130 Luck Lane
Marsh
Huddersfield

Project No.	Project Title
2022 Enquiry 23	**proposed ground**

Drawn No.	Reviewed Title	Revision
106		C

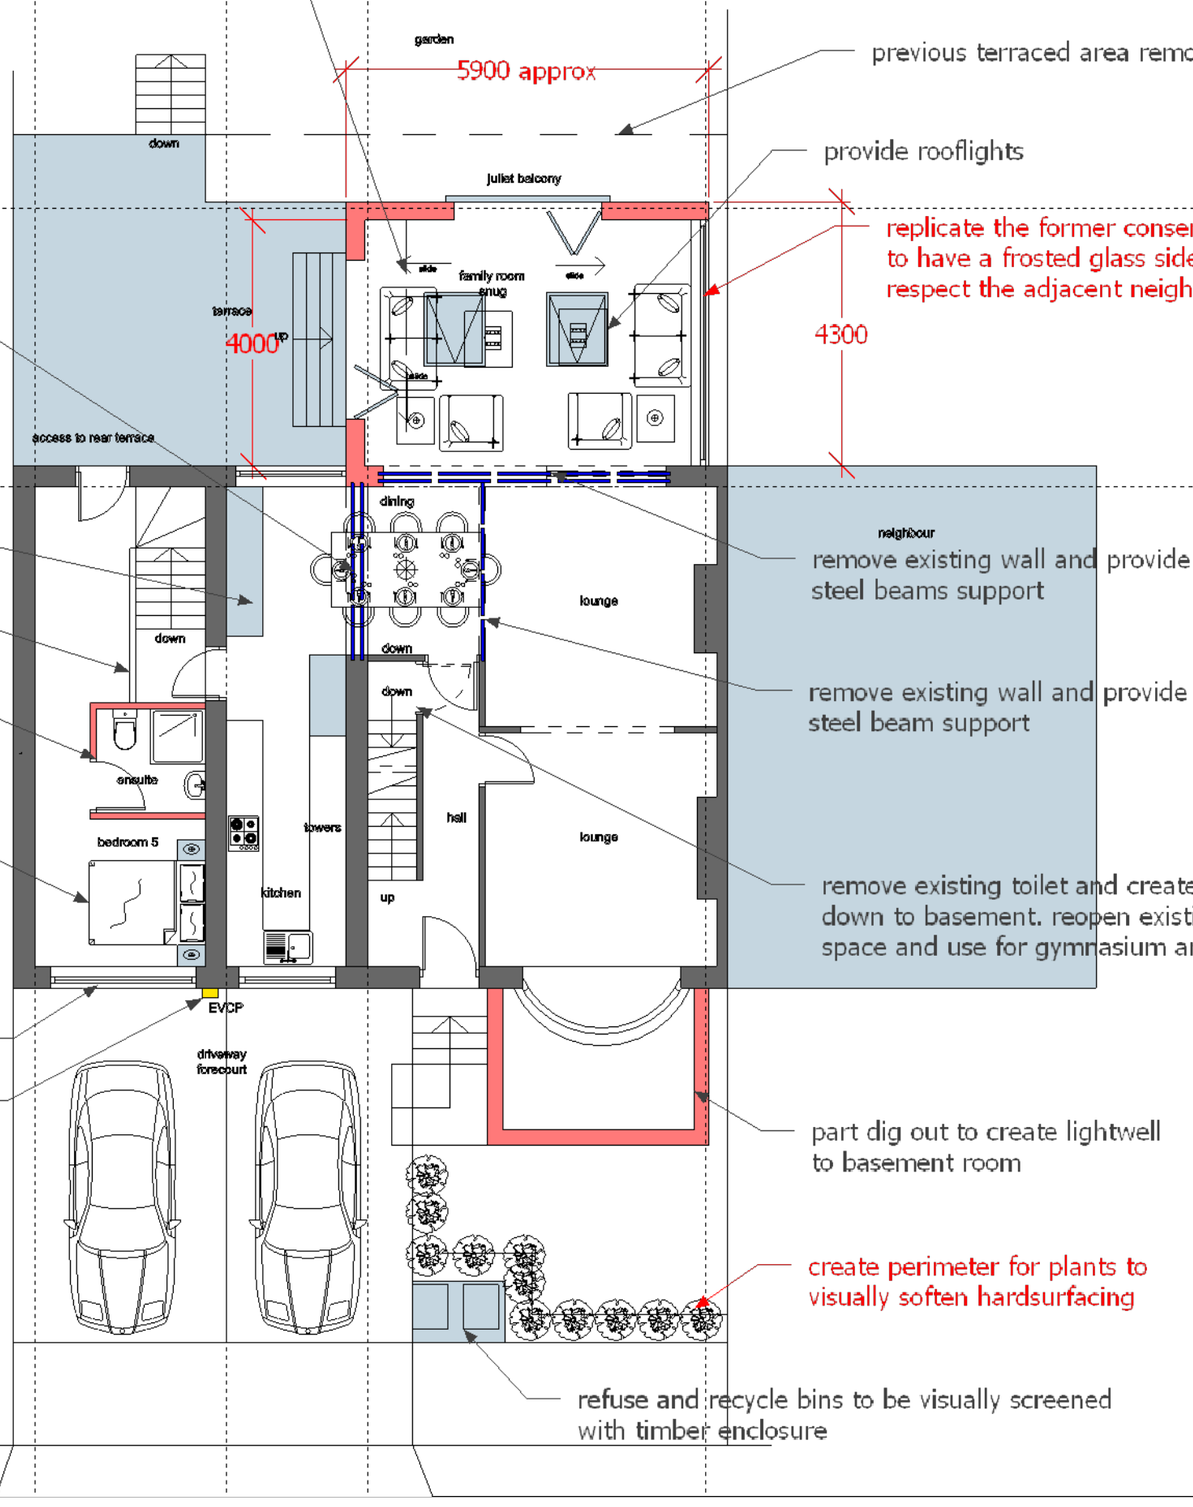
remove existing sun room as it was too hot in summer and too cold in winter and create a new rear extension over and dig out existing fill over the terraced area and use space efficiently to provide games room underneath

existing steel support may need to be modified to suit open planned space

additional kitchen units added

improve the existing stair access

create ensuite

convert former garage into a bedroom the floor may need tanking to suit insulate the walls and the roof to suit

provide large window to suit

provide an electric vehicle charging point

previous terraced area removed

provide rooflights

replicate the former conservatory to have a frosted glass sides to respect the adjacent neighbour

remove existing wall and provide steel beams support

remove existing wall and provide steel beam support

remove existing toilet and create new stair down to basement. reopen existing basement space and use for gymnasium and games room

part dig out to create lightwell to basement room

create perimeter for plants to visually soften hardsurfacing

refuse and recycle bins to be visually screened with timber enclosure

revisions
A 30-9-2022
soft landscape strip added on perimeter to visually soften hardsurfacing

B 6-10-2022
rear extenison width reduced to original house width the garage level have been retained and the bedroom and ensuite formed rather than rasing the roof, additional kitchen unts added to the existing space to enlarge the kitchen

C 10-9-2022
updated rear extenison width reduced to original house width the garage level have been retained and the bedroom and ensuite formed rather than rasing the roof, additional kitchen unts added to the existing space to enlarge the kitchen
